Groundwater Application Review Summary Form

Application # G- 19146

PUBLIC INTEREST REVIEW FOR GROUNDWATER APPLICATIONS

A. GENERAL INFORMATION: Applicant's Name: J and J Family LLC County: Marion

Water-Level Measurements in Nearby Wells-POAs 1, 2, 3, 4, and 5

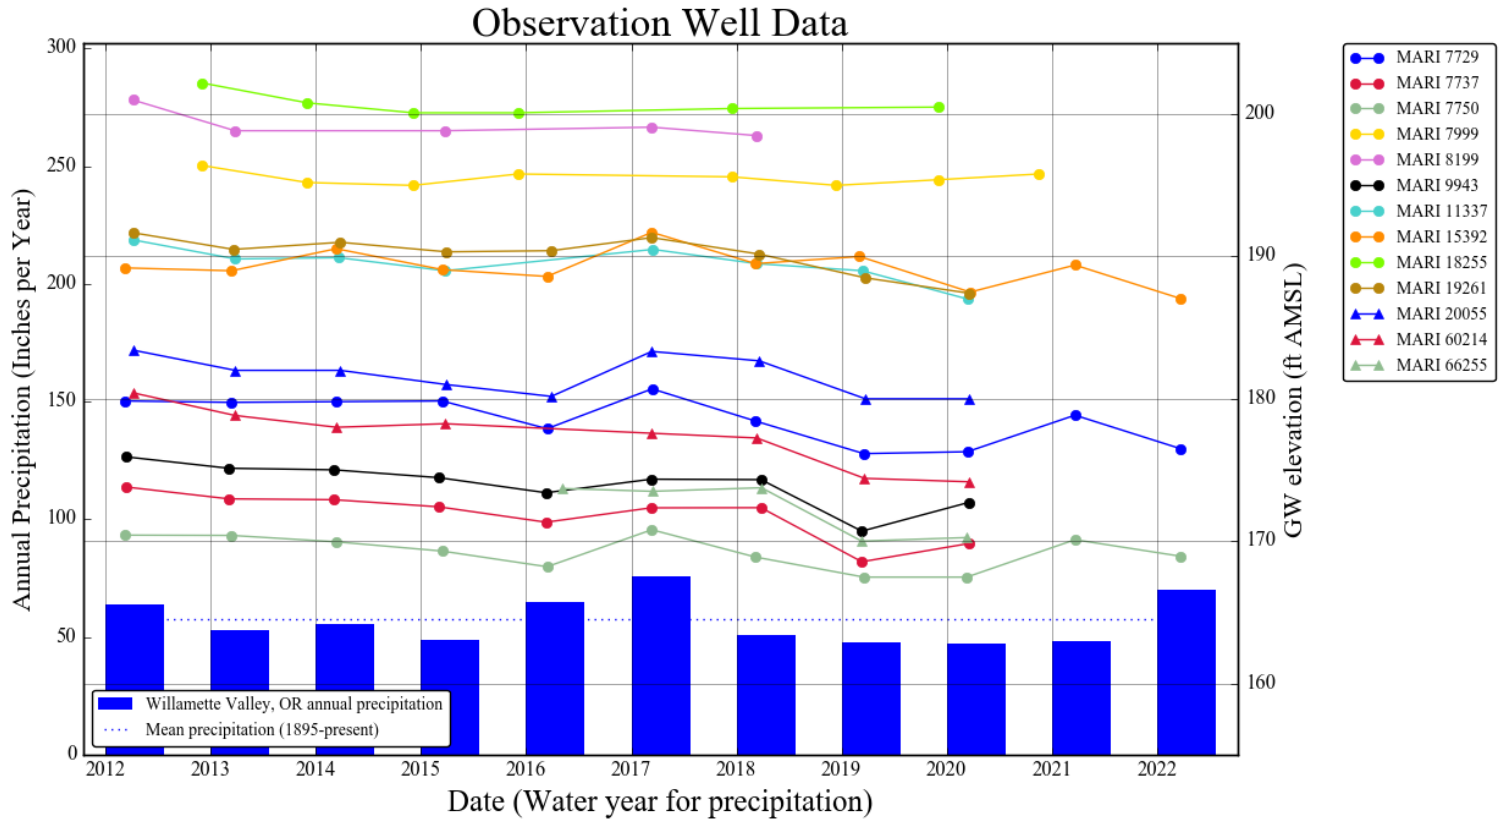
Water level trends for wells near (0 to 2 miles) POAs 1, 2, 3, 4 and 5 that utilize the CRBG and have SWLs within 100 ft in elevation to the POAs' SWLs are declining (see Water Levels Measurements in Nearby Wells-Wells 1, 2, 3, 4 and 5). Of the 13 wells included, 4 have declined between 1 and 2 ft in the prior 10 years (MARI 7750, MARI 7999, MARI 8199, 18255). The remaining 9 wells have declined between 2 and 5 ft in the prior 10 years. There is not a preponderance of evidence to support that the water levels in the CRBG groundwater reservoir are declined excessively or excessively declining; therefore, the groundwater reservoir is not over-appropriated.

Water-Level Measurements in Nearby Wells-POAs 6, 7, and 8

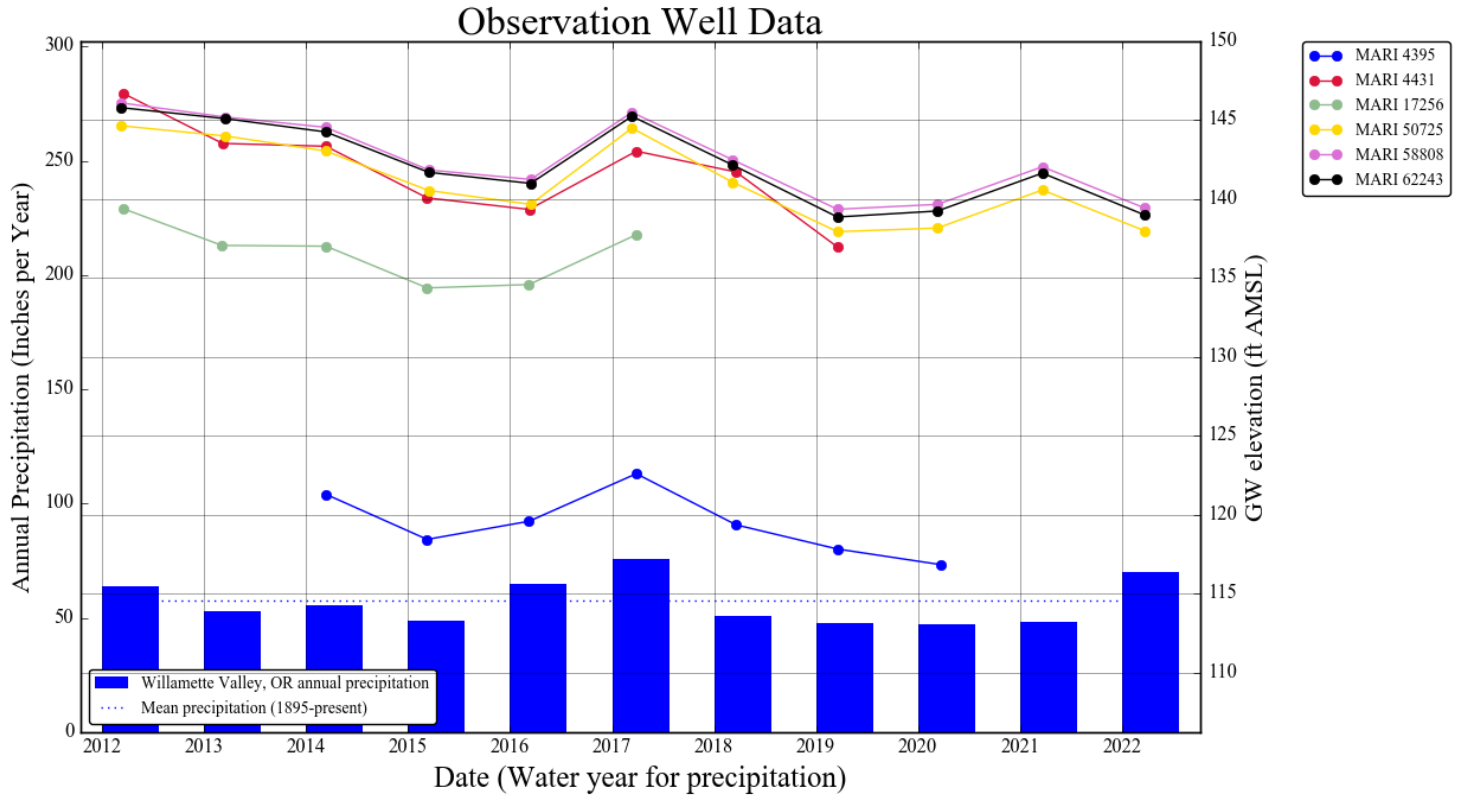
Water level trends for wells near (0 to 2 miles) POAs 6, 7, and 8 that utilize the alluvial aquifer are declining (see Water Levels Measurements in Nearby Wells-Wells 6, 7, and 8). Of the 6 wells included, 1 has declined between 1 and 2 ft in the prior 10 years (MARI 17256). The remaining 5 wells have declined between 4 and 10 ft in the prior 10 years. Well 2 (MARI 7750), Well 4 (MARI 15392), and Well 7 (MARI 58808) have extended datasets: MARI 7750 has declined 22.5 ft since 1992; MARI 15392 has declined 5.45 ft since 1992; MARI 58808 has declined 8.61 ft since 2006 (see Water Levels Measurements MARI 7750, MARI 15392, and MARI 58808). There is not a preponderance of evidence to support that the water levels in the alluvial groundwater reservoir are declined excessively or excessively declining; therefore, the groundwater reservoir is not over-appropriated.

**Theis Drawdown Analysis
Well 1**

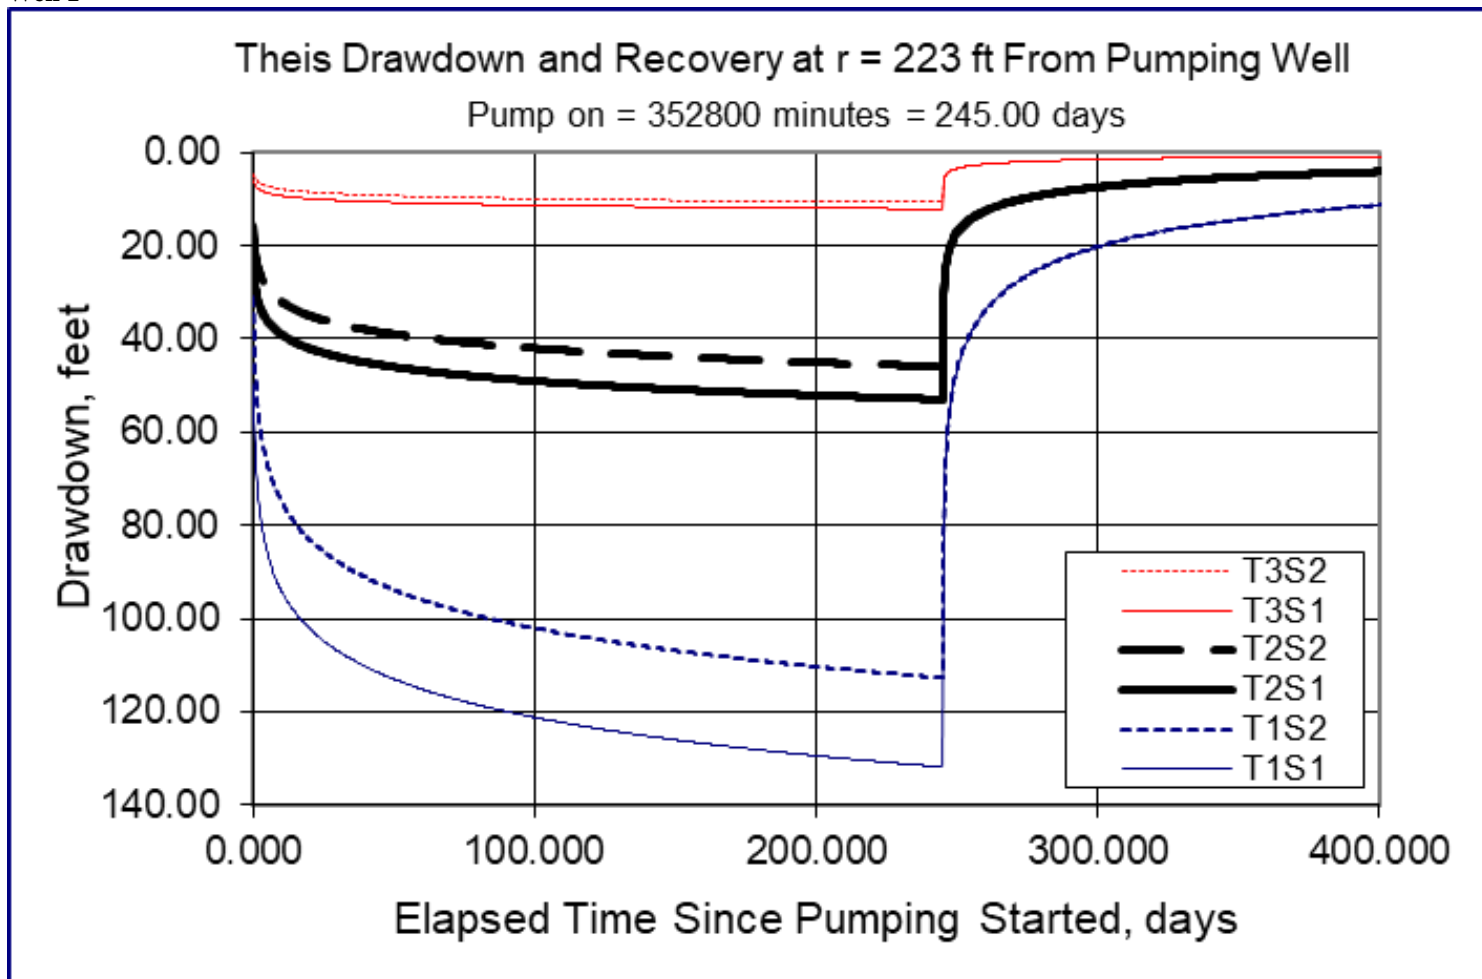
The nearest CRB groundwater user to POA 1 is MARI 19360 (an exempt domestic well), located ~223 ft southeast of the POA, at an elevation of ~259 ft msl. The well log does not record the latitude or longitude for MARI 19360, but it is recorded to be located on taxlot 500 at 585 74th Ave SE Salem, Oregon. Due to the domestic use indicated on the well log, it was assumed that MARI 19360 is co-located in the vicinity of the developed structures on taxlot 500. MARI 19360 is completed to a depth of 197 ft bls and with a WBZ at 155-197 ft bls [62-104 ft msl]. The seal of POA 1 extends to 112 ft bls [137 ft msl]. It is likely the proposed use would cause some degree of well-to-well interference with MARI 19360. To assess the degree of drawdown, a Theis drawdown analysis was conducted for the proposed use (see attached Theis Drawdown Analysis-Well 1). **Results indicate that the proposed use of POA 1 is likely to cause well-to-well interference with MARI 19360 that exceeds the threshold under the standard condition for basalt aquifers in the Willamette Basin.**

Well 2

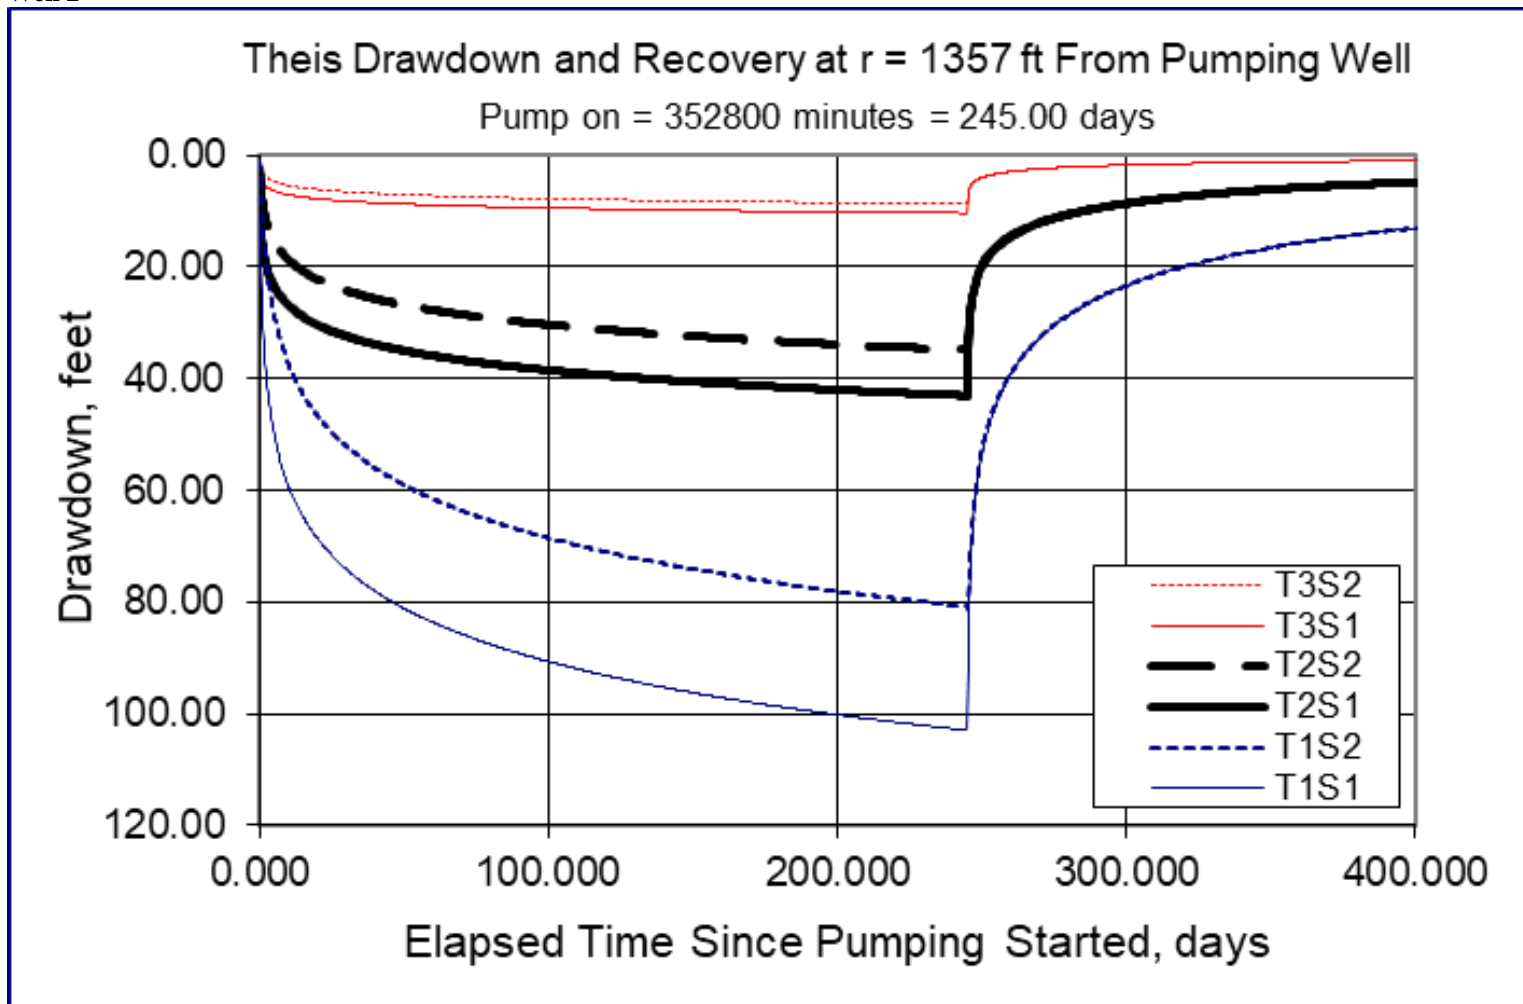
The nearest CRB groundwater user to POA 2 is MARI 56896 (an exempt domestic well), located ~ 1,357 ft to the south of the POA, at an elevation of ~226 ft msl. The well log does not record the latitude or longitude for MARI 56896, but it is recorded to be located on taxlot 200 at 7235 State St NE Salem, Oregon. The center of the taxlot is the assumed location of MARI 56896. MARI 56896 utilizes a WBZ from 330 to 537 ft bls [-104 to -311 ft msl]. POA 2 has a split seal, with the upper portion extending from the surface to 20 ft bls [230 to 210 ft msl] and the lower portion from 150 to 160 ft bls [70 to 80 ft msl], likely not sealing through the WBZ that MARI 56896 utilizes. It is likely the proposed use would cause some degree of well-to-well interference with MARI 56896. To assess the degree of drawdown, a Theis drawdown analysis was conducted for the proposed use (see attached Theis Drawdown Analysis-Well 2). **Results indicate that the proposed use of POA 2 is likely to cause well-to-well interference with MARI 56896 that exceeds the threshold under the standard condition for basalt aquifers in the Willamette Basin.**

Well 3

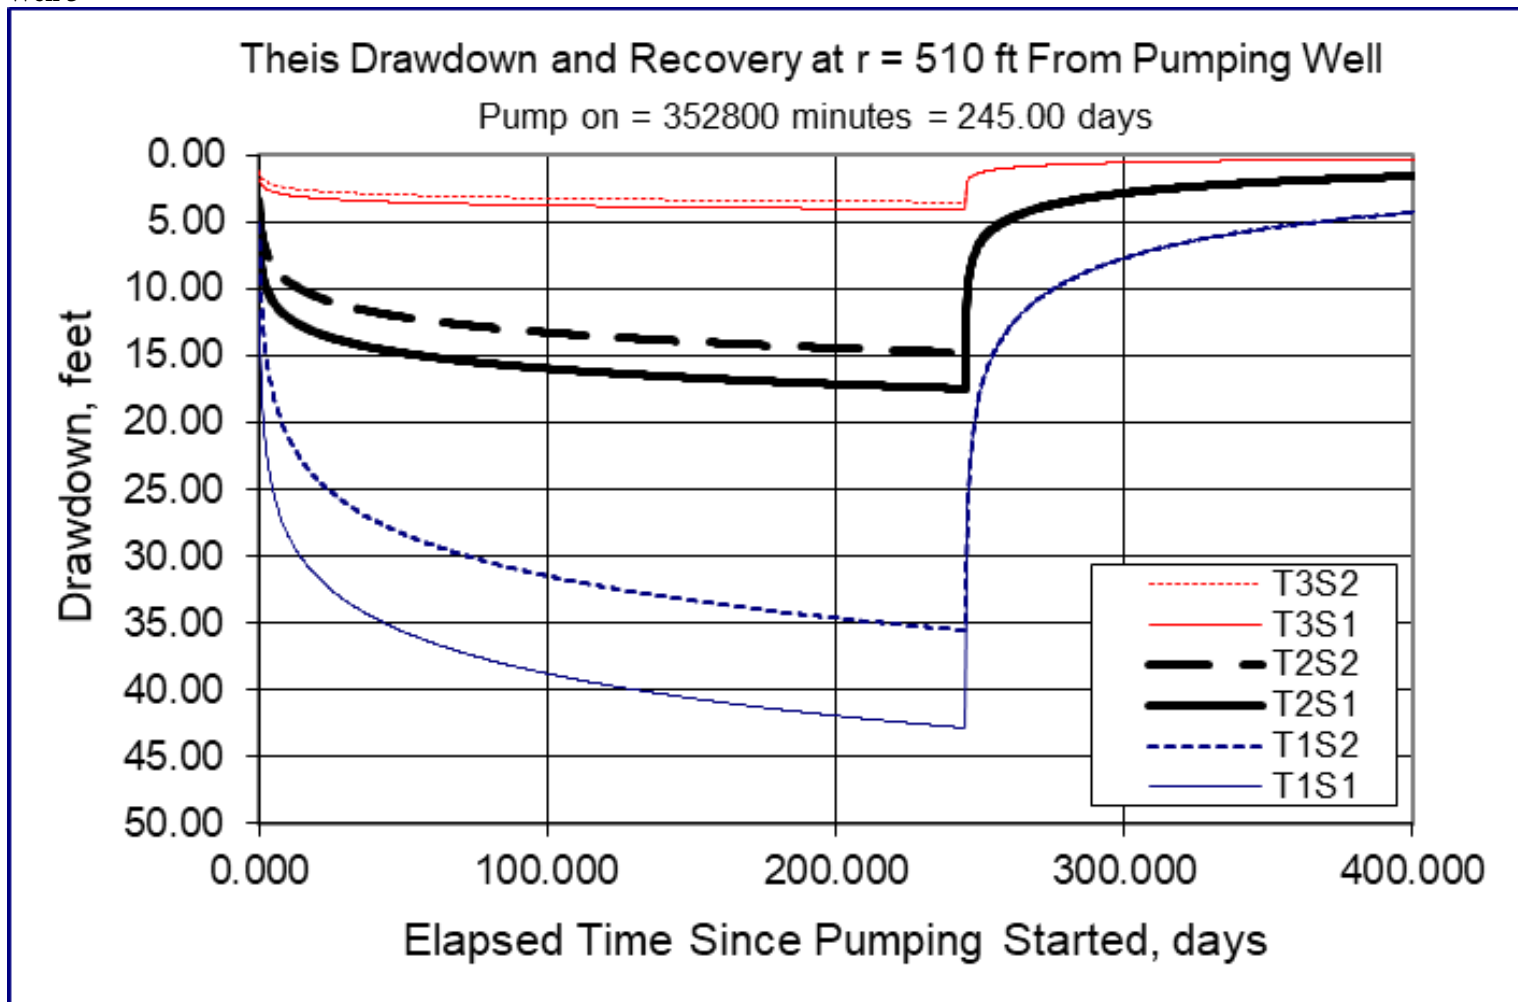
The nearest CRB groundwater user to POA 3 is MARI 16615 (an exempt domestic well), located ~ 510 ft to the southwest of the POA, at an elevation of ~283 ft msl. The well log does not record the latitude or longitude for MARI 16615, but it is recorded to be located at 616 74th Ave SE Salem, Oregon. Without additional location information, it was assumed the well is located in the center of the developed area on the taxlot at the indicated address. MARI 16615 utilizes a WBZ from 188 ft bls to the completed depth 200 ft bls [83 to 95 ft msl]. The seal of POA 3 extends to 79 ft bls [184 ft msl]. It is likely the proposed use would cause some degree of well-to-well interference with MARI 16615. To assess the degree of drawdown, a Theis drawdown analysis was conducted for the proposed use (see attached Theis Drawdown Analysis-Well 3). **Results indicate that the proposed use of POA 3 is likely to cause well-to-well interference with MARI 19360 that exceeds the threshold under the standard condition for basalt aquifers in the Willamette Basin.**

Well 4

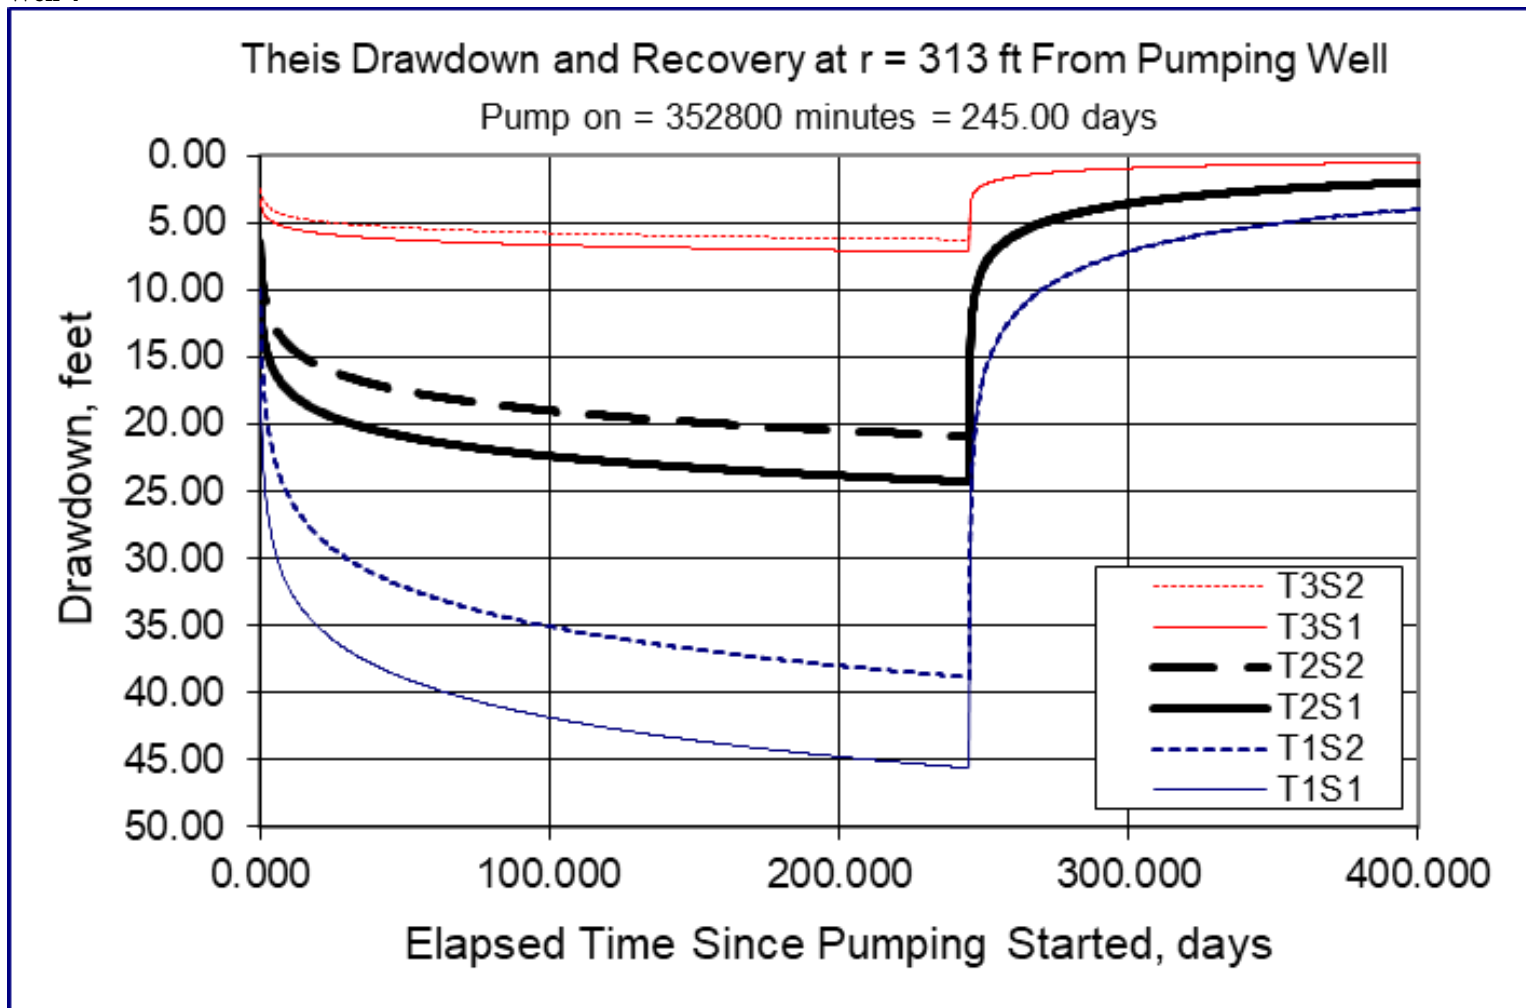
The nearest CRB groundwater user to POA 4 is MARI 66833 (an exempt domestic well) located ~313 ft to the southeast of the POA, at an elevation of 240 ft msl. MARI 66833 utilizes multiple WBZs from 130 to 283 ft bls [-43 to 110 ft msl]. The seal of the POA extends to 83 ft bls [150 ft msl]. It is likely the proposed use would cause some degree of well-to-well interference with MARI 66833. To assess the degree of drawdown, a Theis drawdown analysis was conducted for the proposed use (see attached Theis Drawdown Analysis-Well 4). **Results indicate that the proposed use of POA 4 is likely to cause well-to-well interference with MARI 66833 that exceeds the threshold under the standard condition for basalt aquifers in the Willamette Basin.**
